Annex E: Hydrology and Hydraulics

This initial review of the available documents relating to the evaluation of the hydrology and hydraulic studies for the design and operation of the Don Sahong Hydropower takes into account design and modelling documents which were available for review as of December 2014. They are listed in the reference section.

Figure 1: Domains of the Headpond Model and Upstream Model, noting that the Upstream Model includes the entire area covered by the Headpond Model. Upstream Model boundaries are numbered (SMEC 2014b).

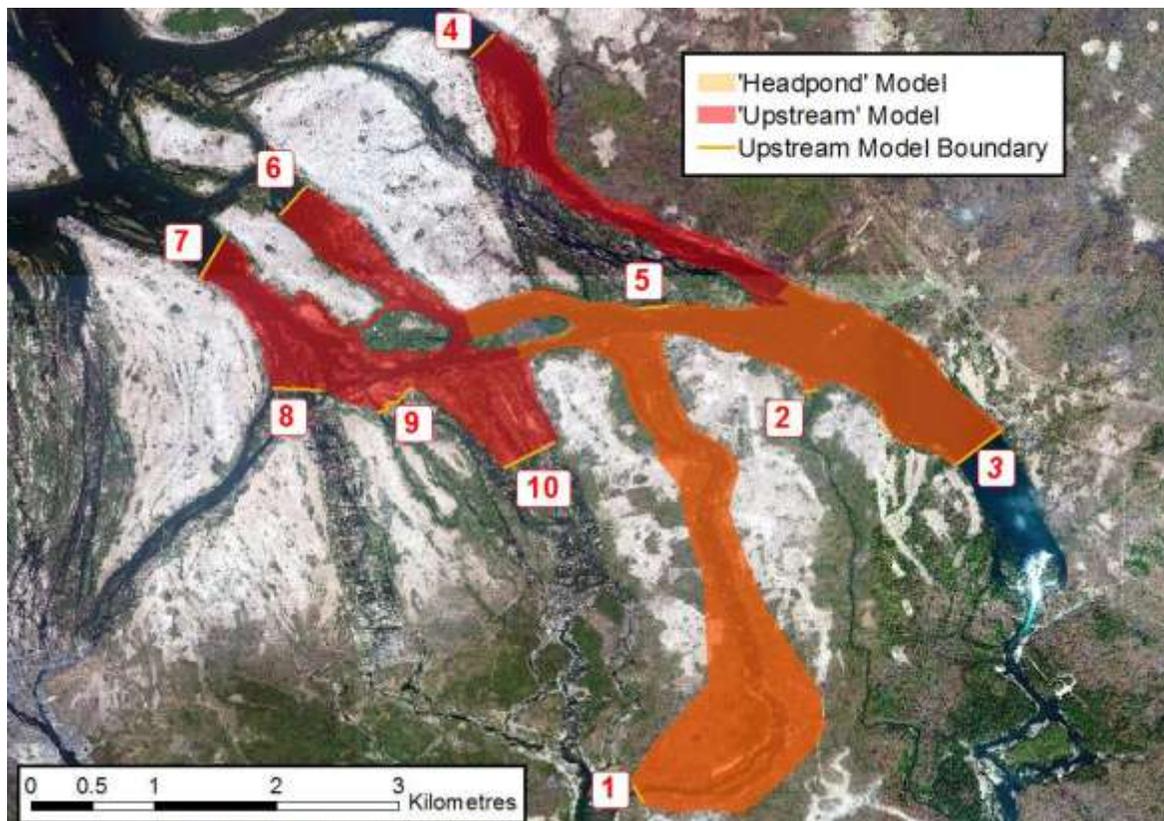
Basic modelling parameters like modelling time step and closely related to that determined Courant numbers at critical locations are missing. The latter provide important information on the quality in terms of spatial resolution of the finite element mesh.
